Technical product information

Topic	Condensation within the cabin
Market area	Bentley: worldwide (2WBE),Hongkong-Macau (5HK)
Brand	Bentley
Transaction No.	2057965/1
Level	EH
Status	Approval
Release date

New Continental GT/GTC

Figure 1

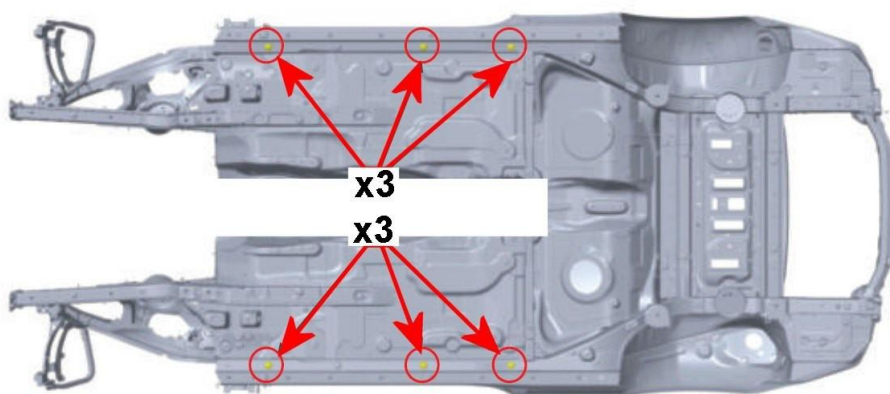
2) Referring to Figure 1

- Remove the x3 right hand sill grommets
- Remove the x3 left hand sill grommets

3) Replace the previously removed grommets using the parts listed in Parts information section
